## **FOREST LAKES PHASE 2 PUD/PRELIMINARY PLAN MINOR AMENDMENT**

### **LETTER OF INTENT**

**SEPTEMBER 2019**

AREA OF LOT  
SHIFT EXHIBIT

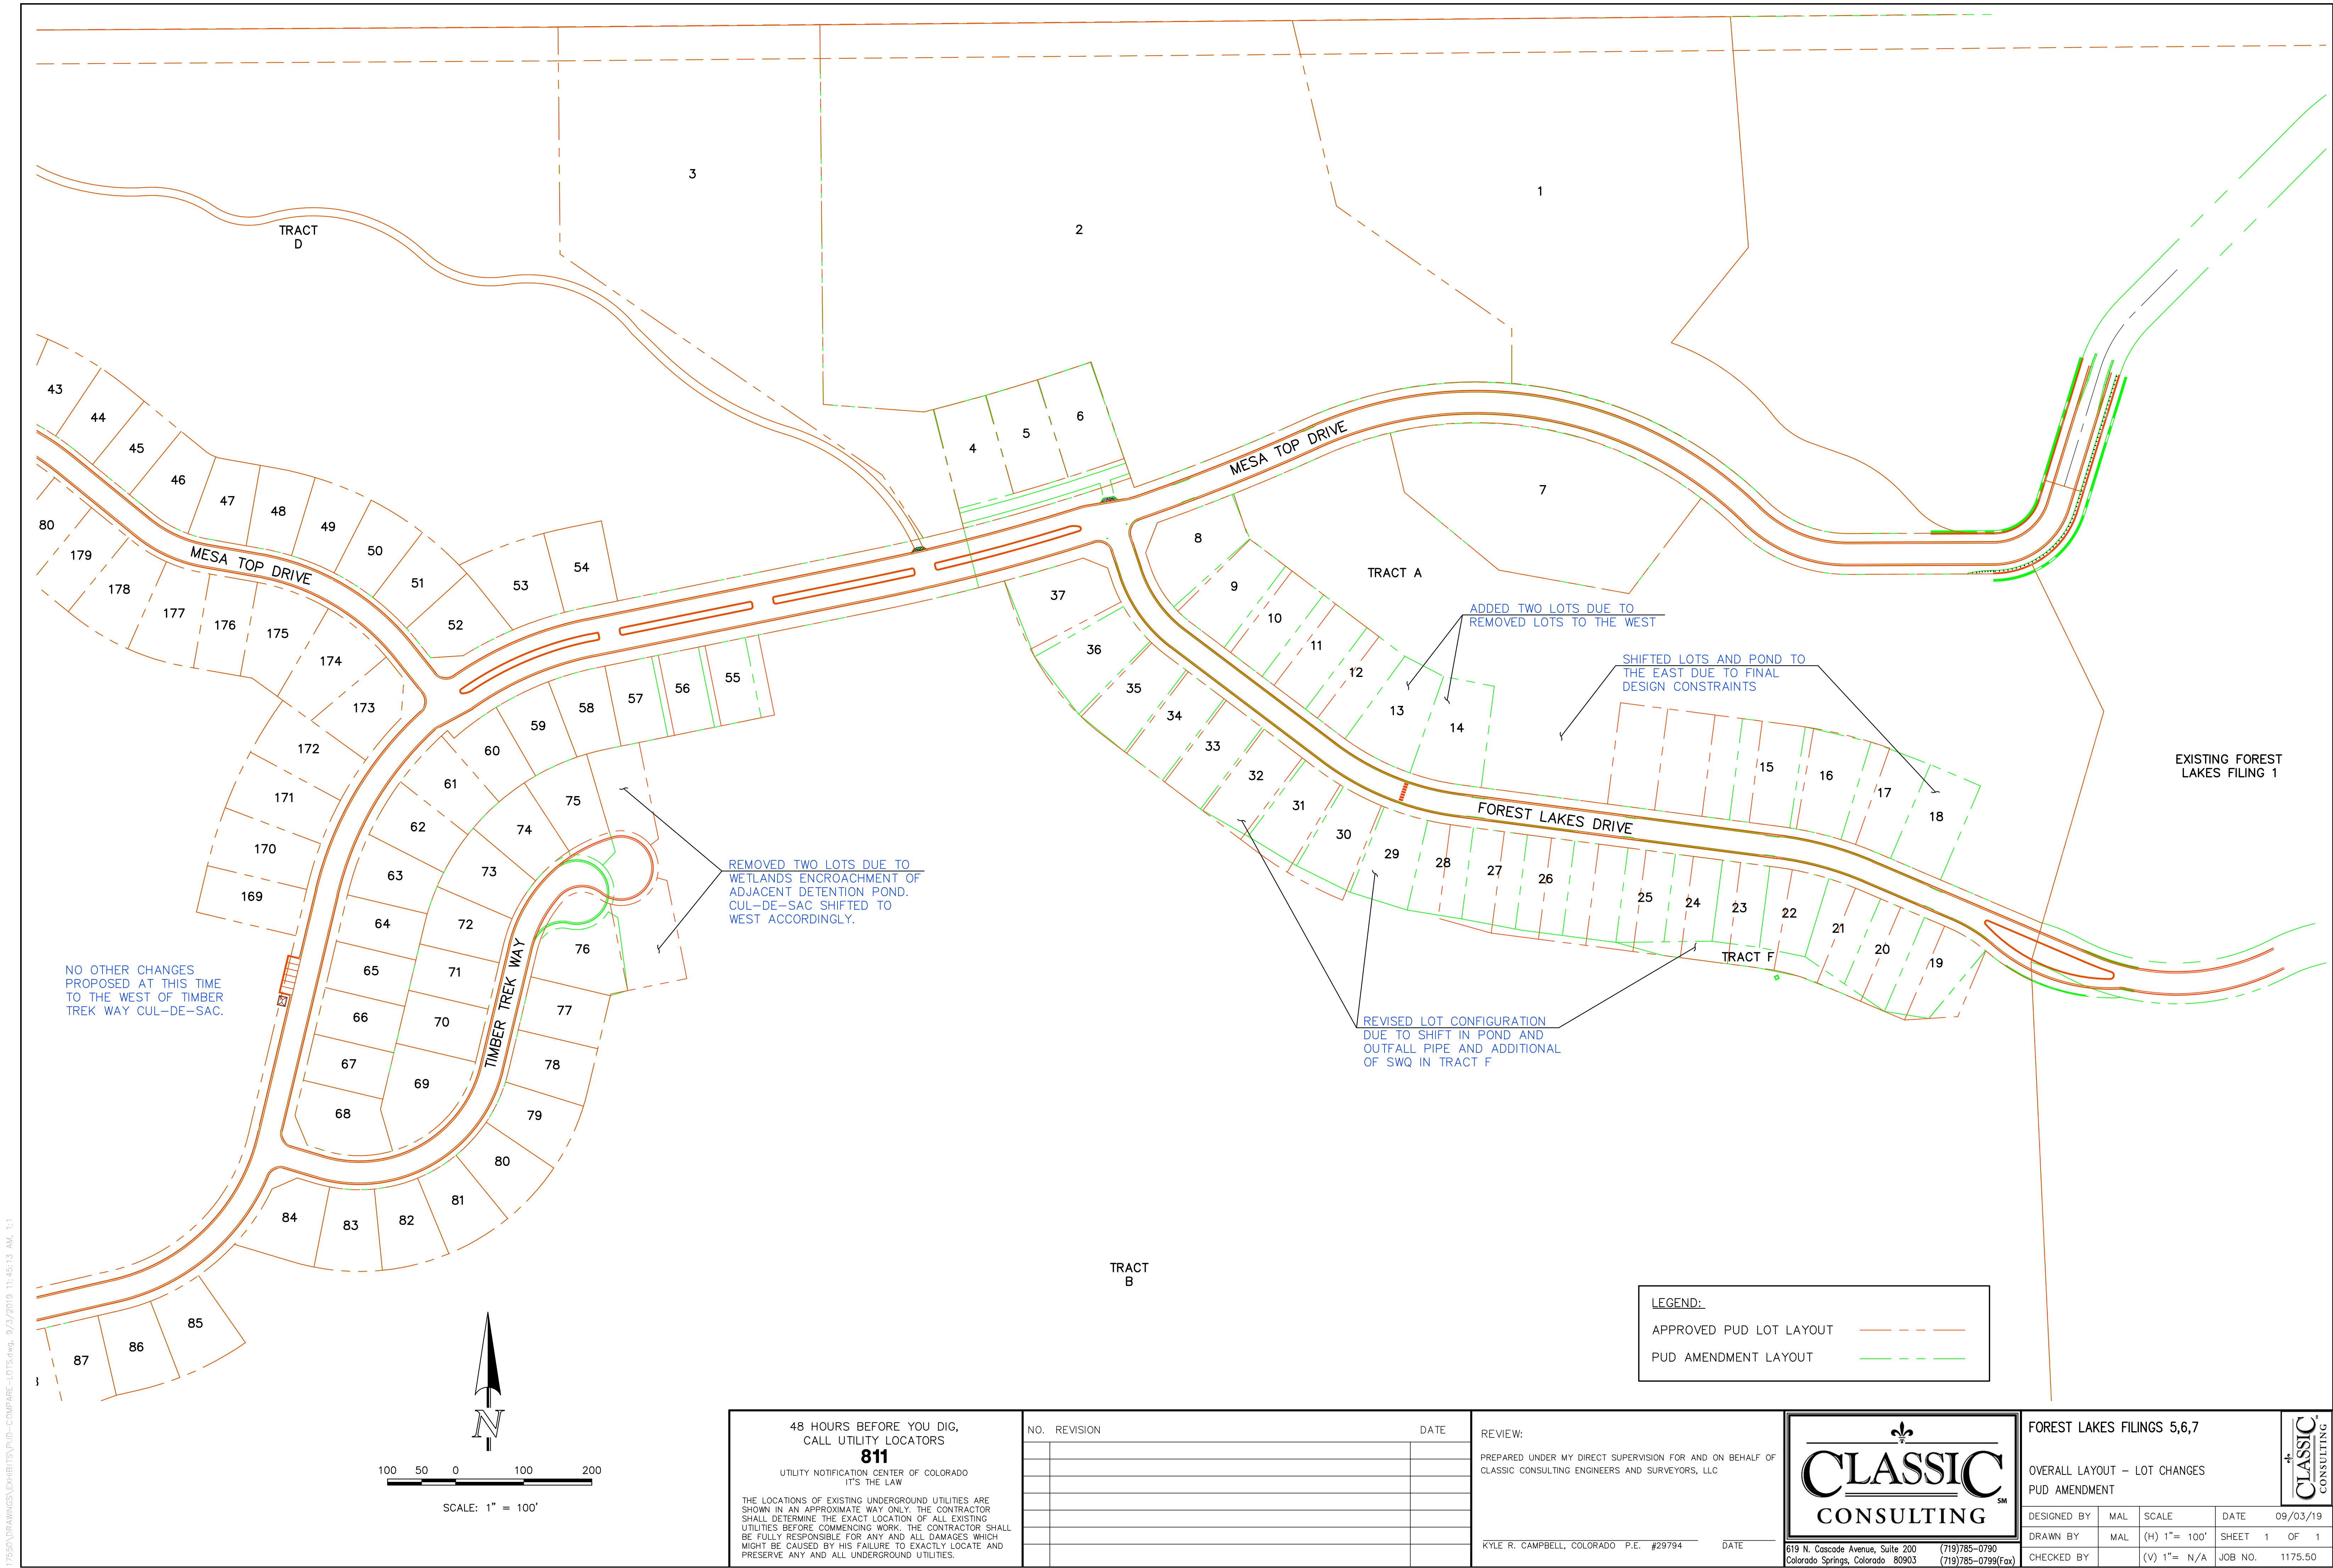
1. Modify the layout and location of detention ponds to remove them from the wetland areas and to improve drainage.
2. Adjust lot numbers, dimensions and locations affected by detention pond changes. (See attached exhibits showing affected lots).
